# PLANNING DIVISION REPORT DEPARTMENT OF PLANNING AND COMMUNITY AND ECONOMIC DEVELOPMENT Of April 2, 2008

# RE: I.D. # 08819: Zoning Map Amendment I.D. 3338 To Rezone 333 W. Washington Avenue from Amended PUD-GDP to Amended PUD-SIP

333 West Washington Avenue - Amended

333 West Washington Avenue Rezoning

Atch. Portion of submission page C 102 "Layout Plan" [10/26/2005]

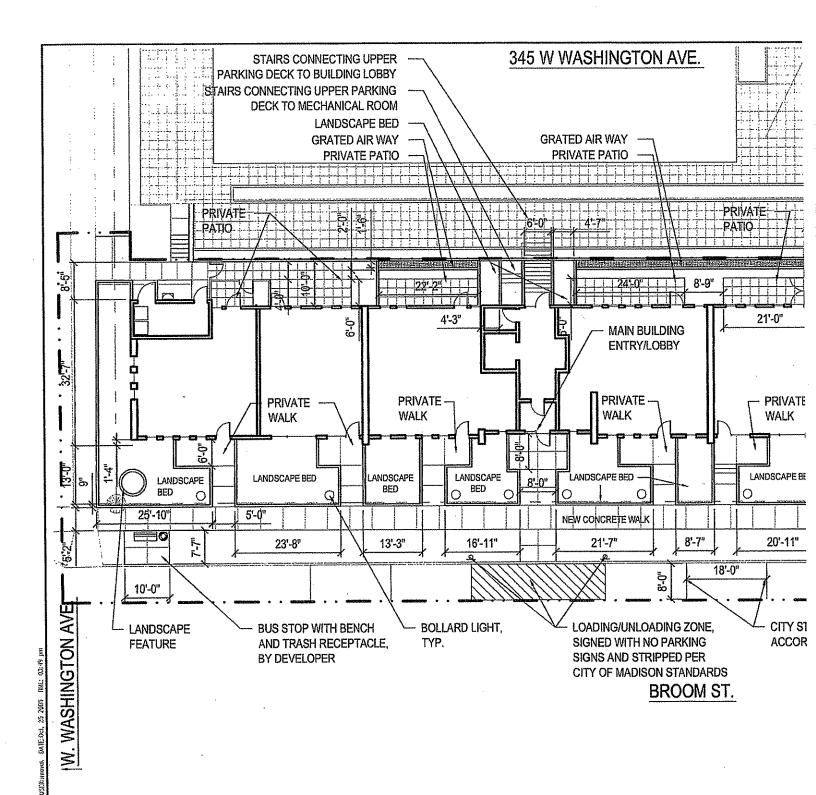
6. The PUD/SIP submitted with this rezoning, and dated October 26 2005, does show the placement of a "new bus shelter" at the bus stop identified above. However, it does point to placing it in the City right-of-way.
